PIN X731.63  
HUNTS POINT INTERSTATE ACCESS IMPROVEMENT PROJECT - CONTRACT 1

## DESIGN UNIT 31A - BRUCKNER CORRIDOR OVER RAILROAD: RW16 RELEASE FOR CONSTRUCTION PLAN

D900047 - BRONX COUNTY, REGION 11  
HUNTS POINT INTERSTATE ACCESS IMPROVEMENT PROJECT - CONTRACT 1  
DESIGN UNIT 31A - BRUCKNER CORRIDOR  
RETAINING WALL RW-16

HUNT'S POINT ACCESS  
IMPROVEMENT PROJECT  
BRONX, NEW YORK  
RW16 COVER SHEET  
T-WALL® RETAINING WALL SYSTEM

RW16 WALL ELEVATION VIEW

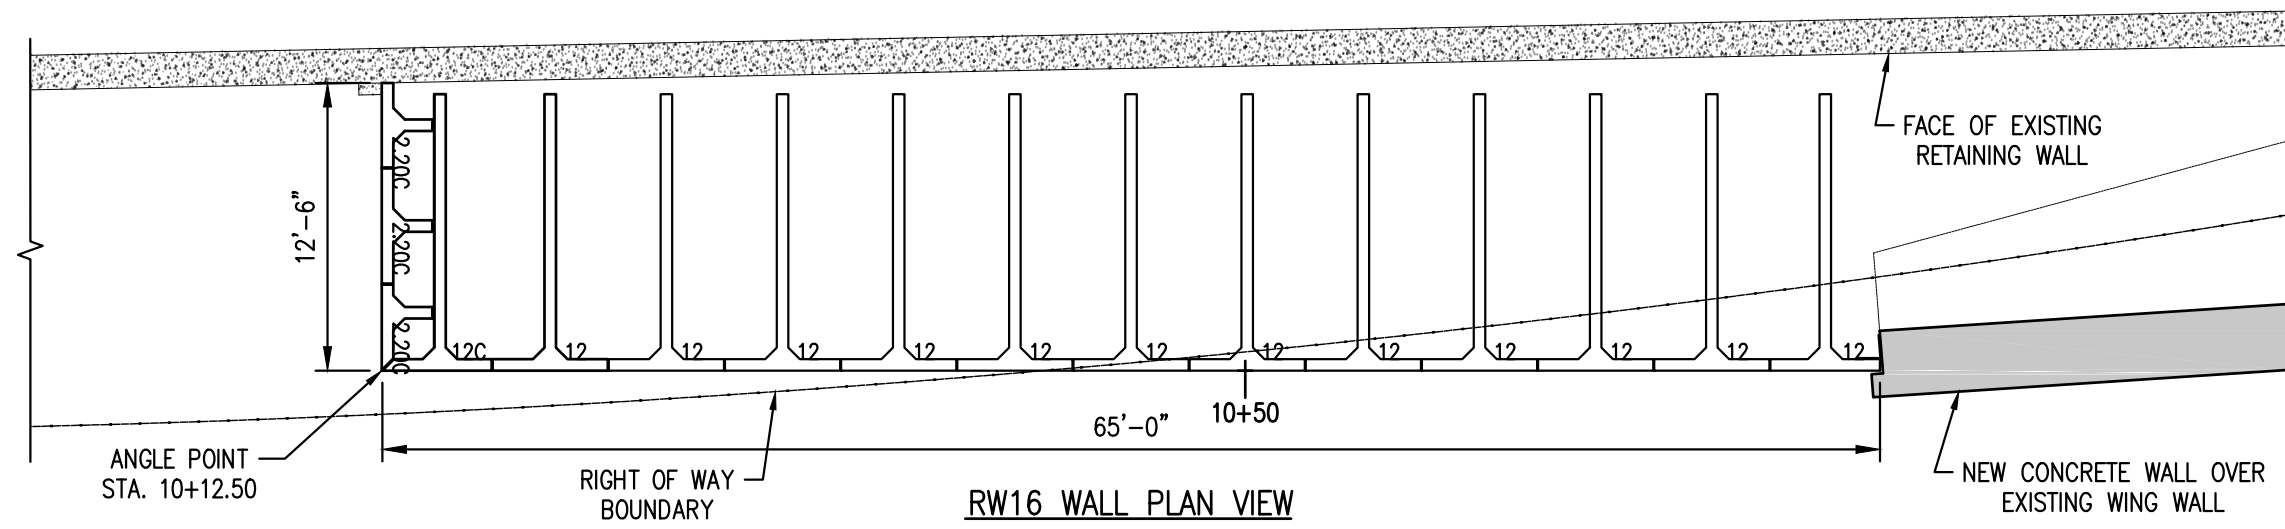
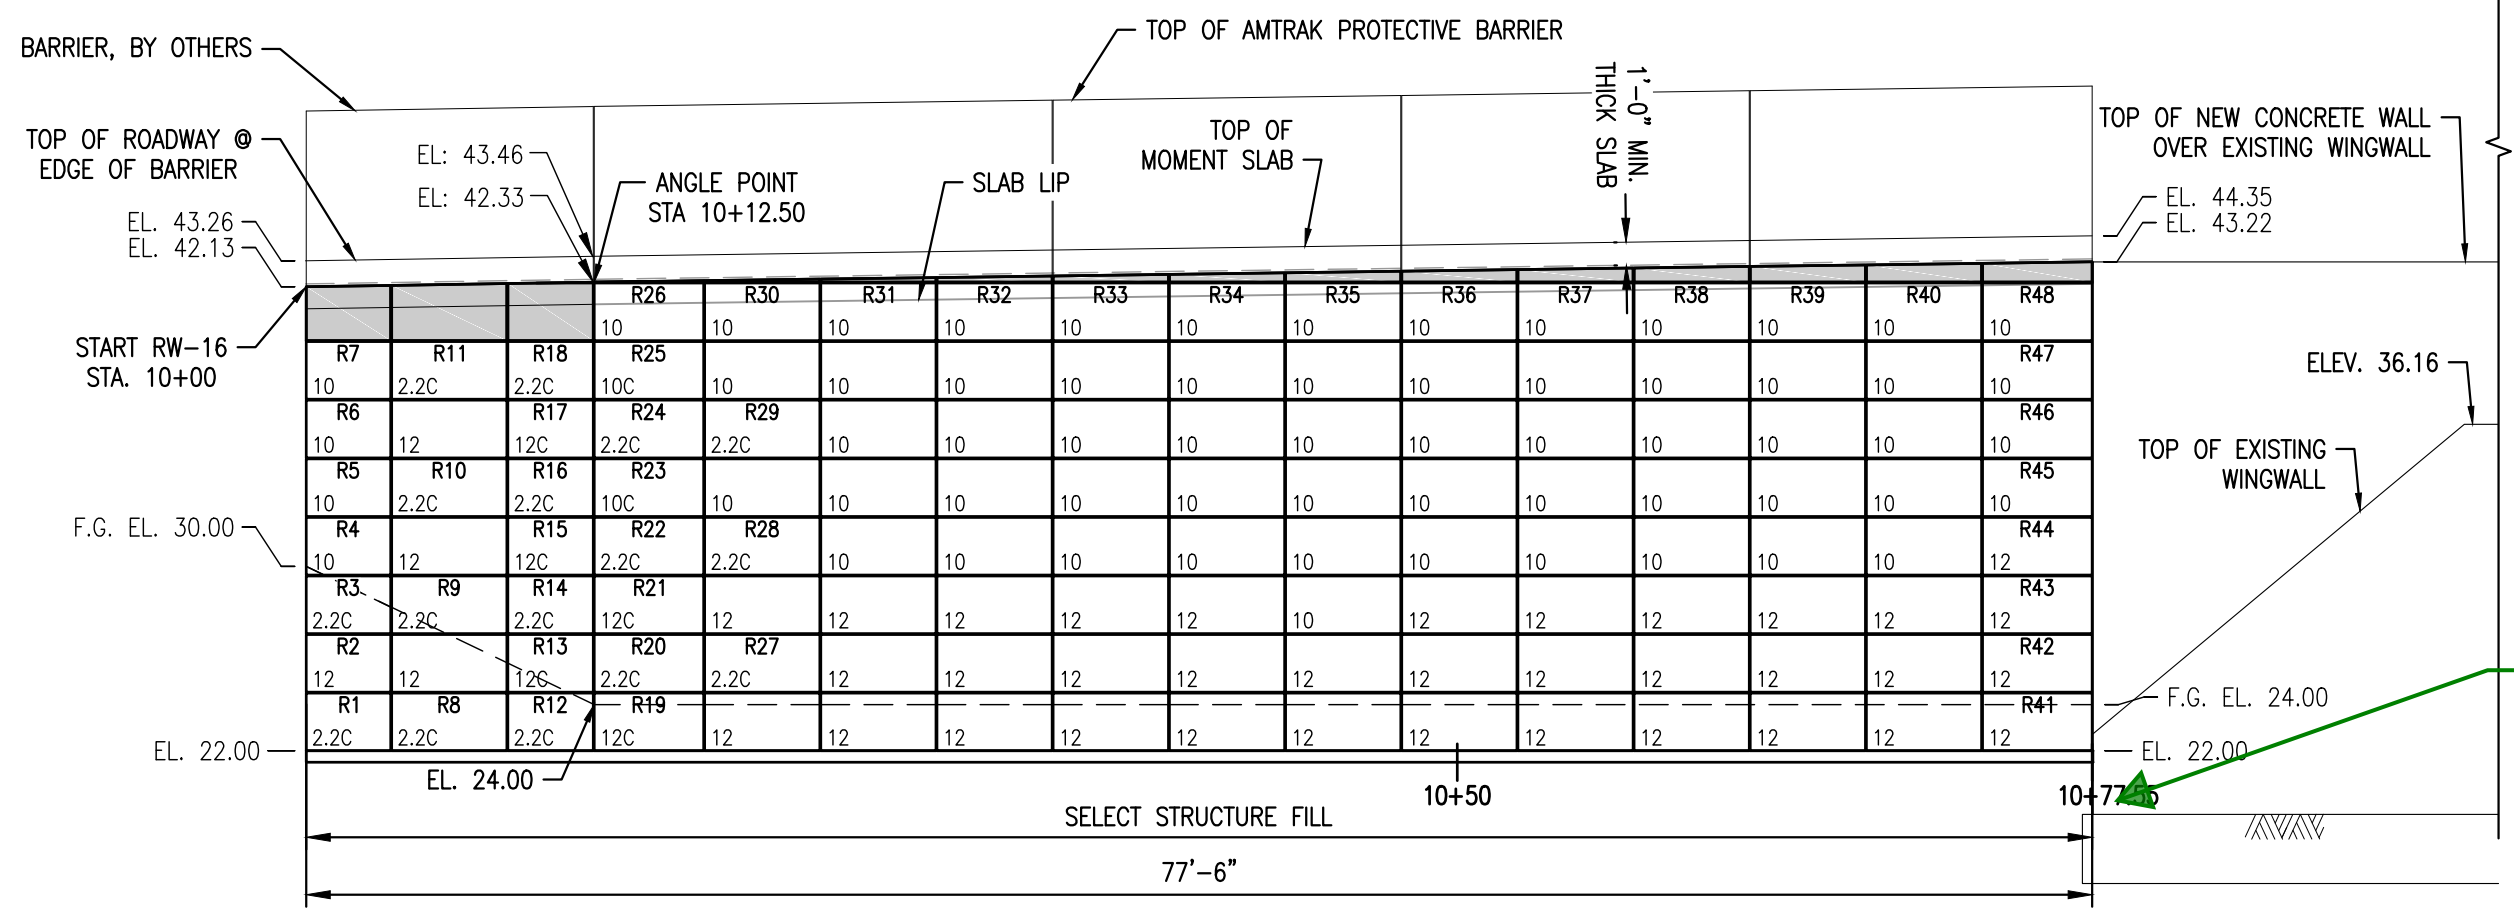
Proposed T-Wall End Station is not consistent with the Design Table on Sheet 2 or DWG No. RW16-05-31A. Please verify and update accordingly.

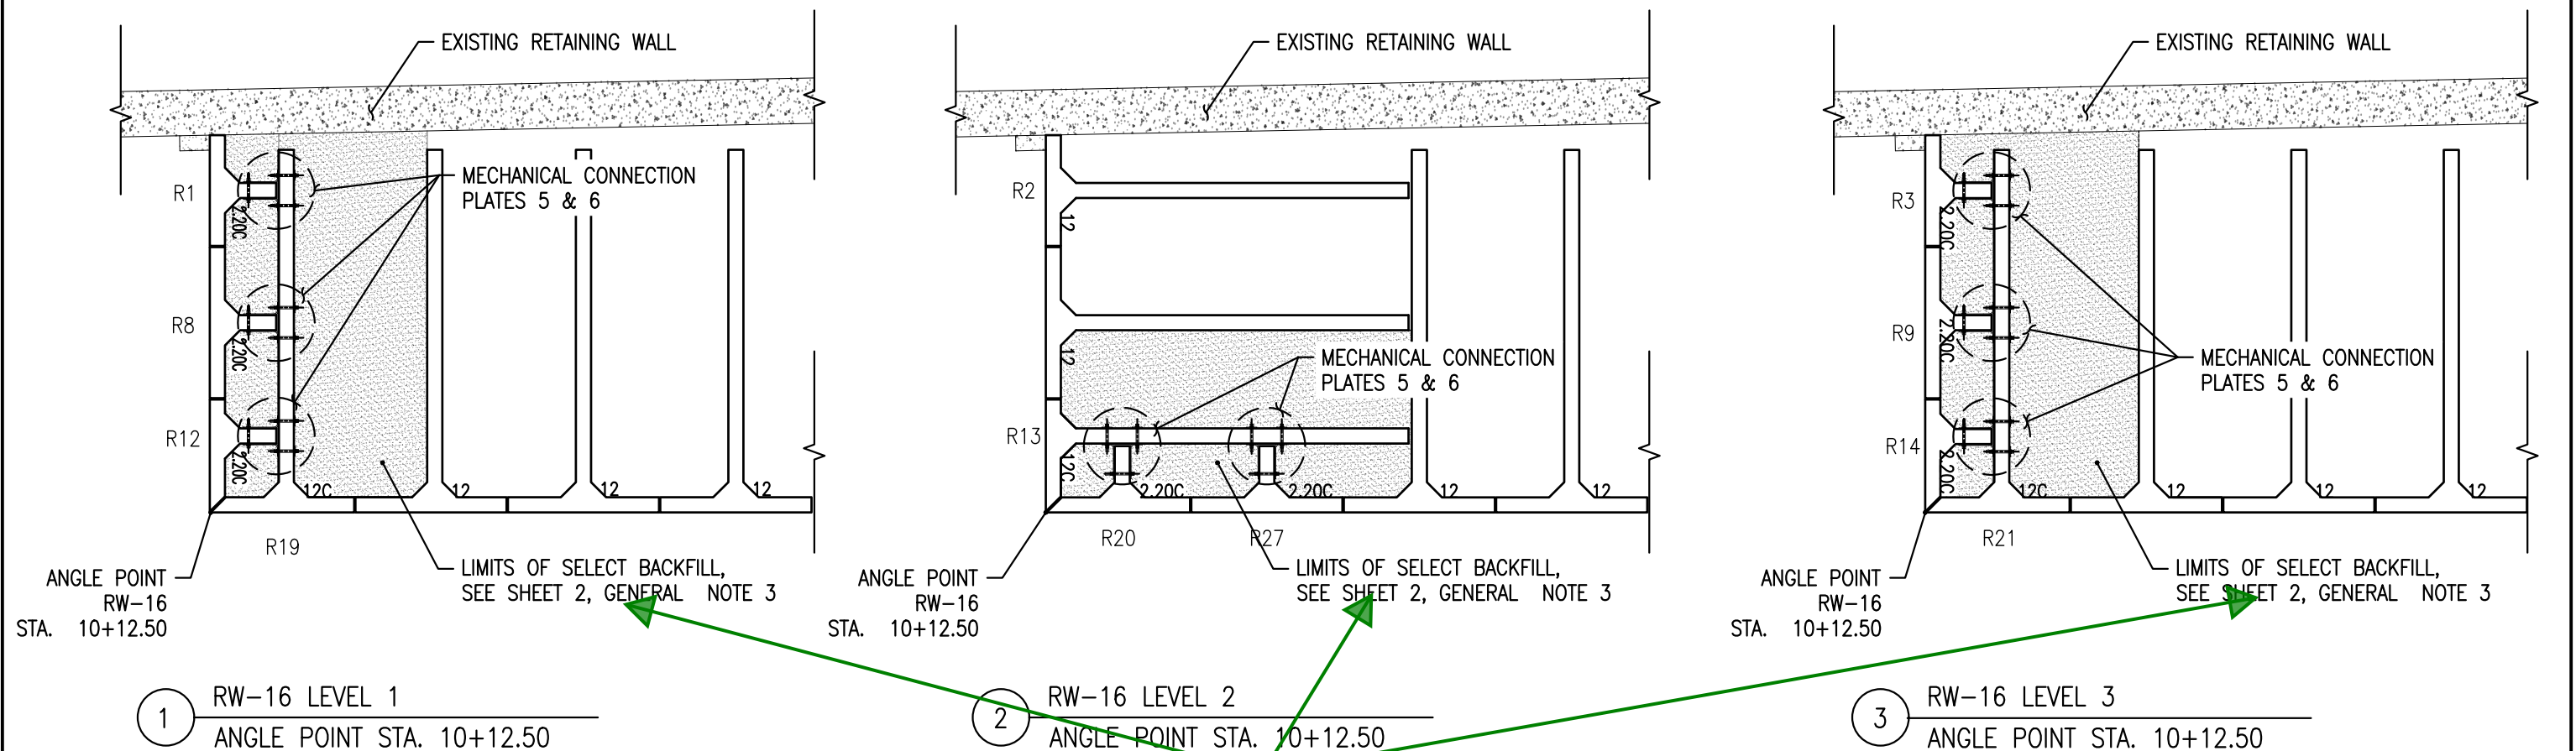
Callouts should say  
"SPECIAL" SELECT  
BACKFILL.

7 RW-16 LEVEL 7  
ANGLE POINT STA. 10+12.50

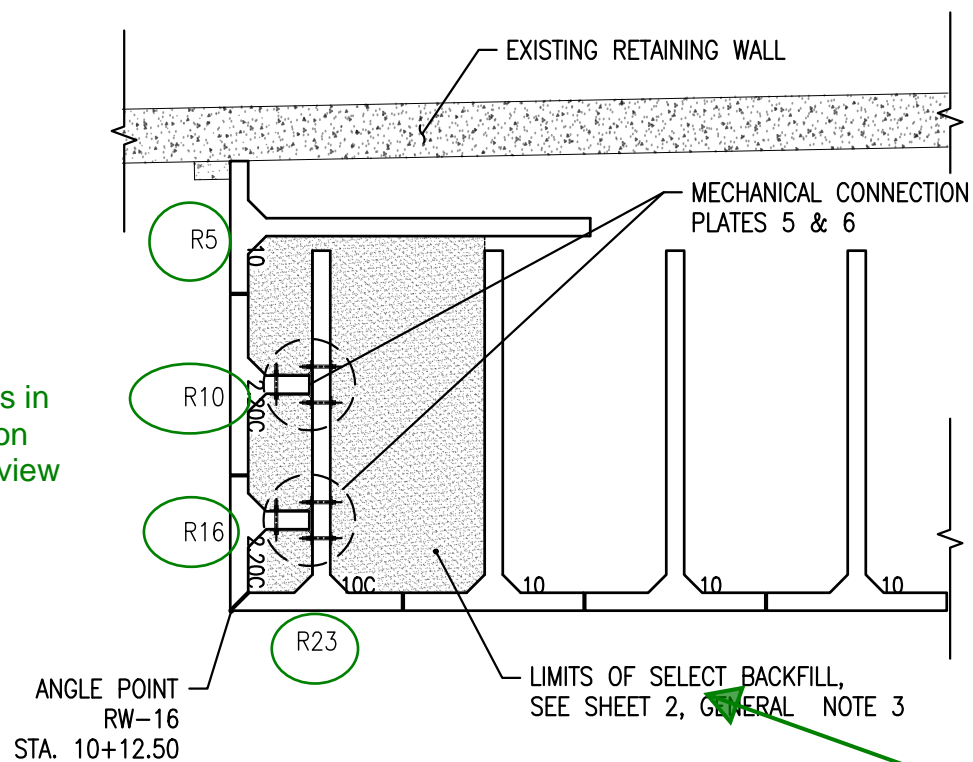
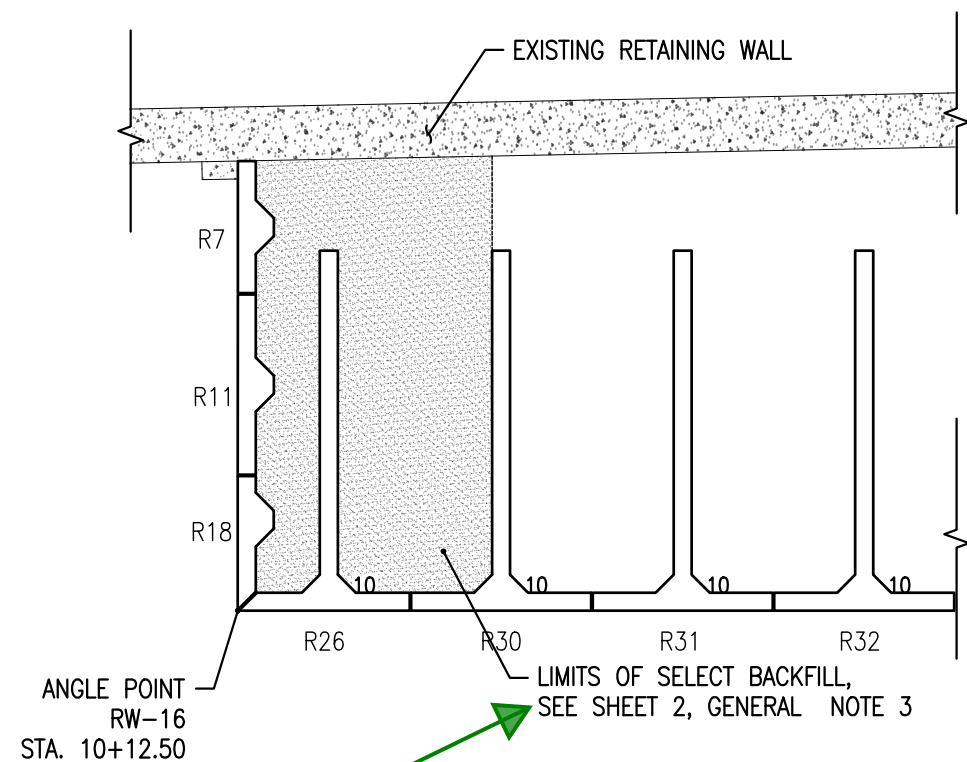
confirm mark numbers in  
detail 7 match those on  
RW16 wall elevation view

D-D PLATE 4 & 6 CONNECTION DETAIL  
10

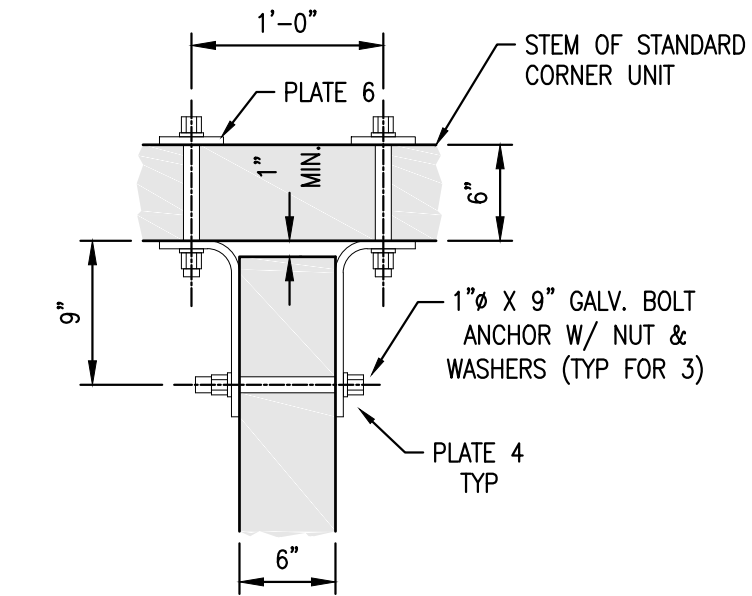
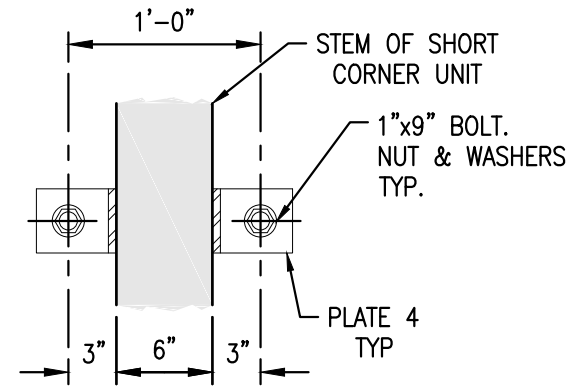
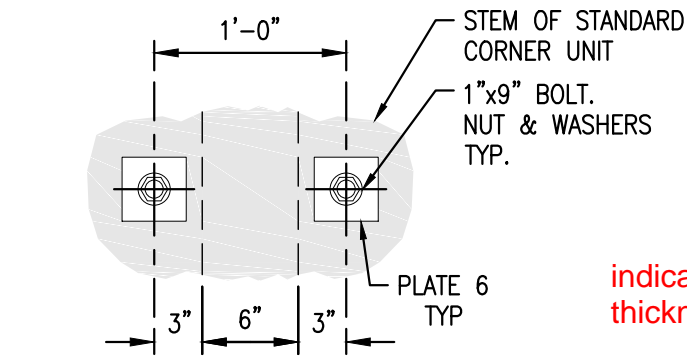
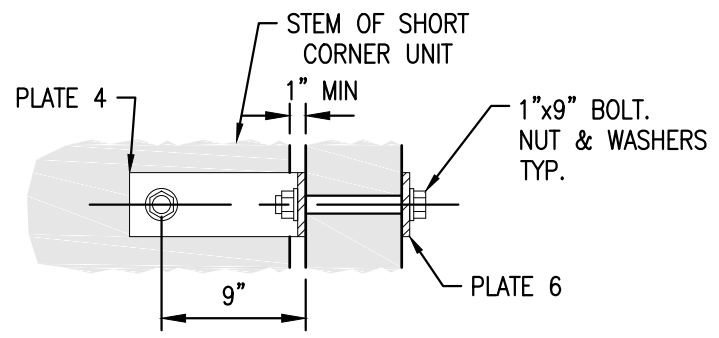
Plates are called out as  
PLATES 5 & 6 on previous  
sheets. Please verify.

indicate plate  
thickness

PLATE 4 DETAIL

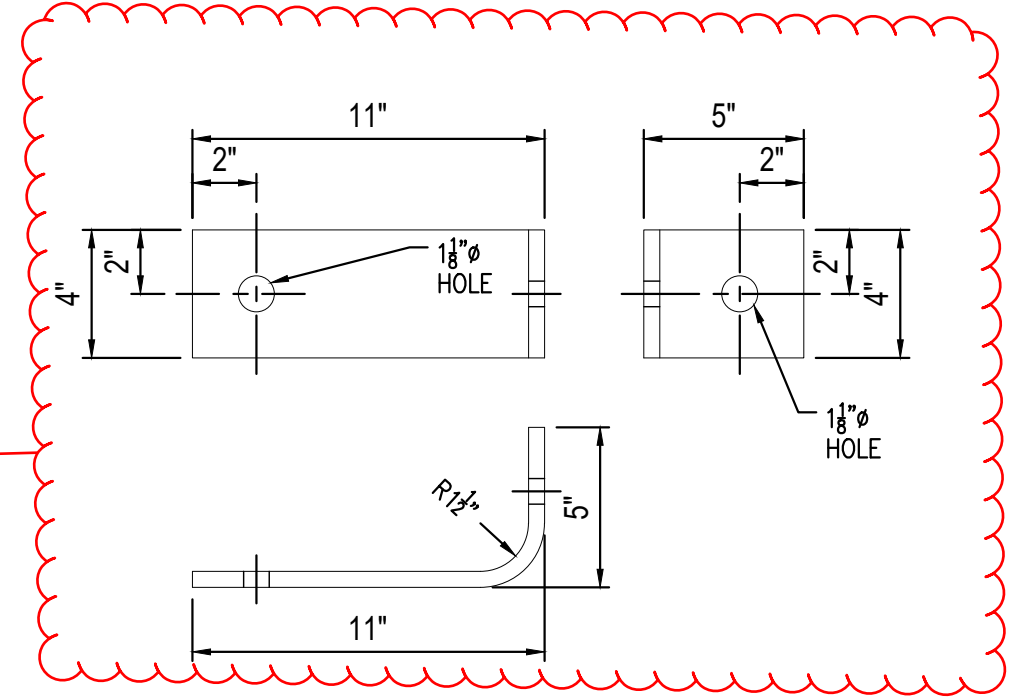
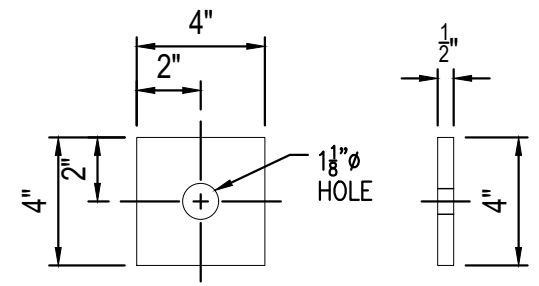
provide material (ASTM  
# and fy) and coating

provide material (ASTM  
# and fy)
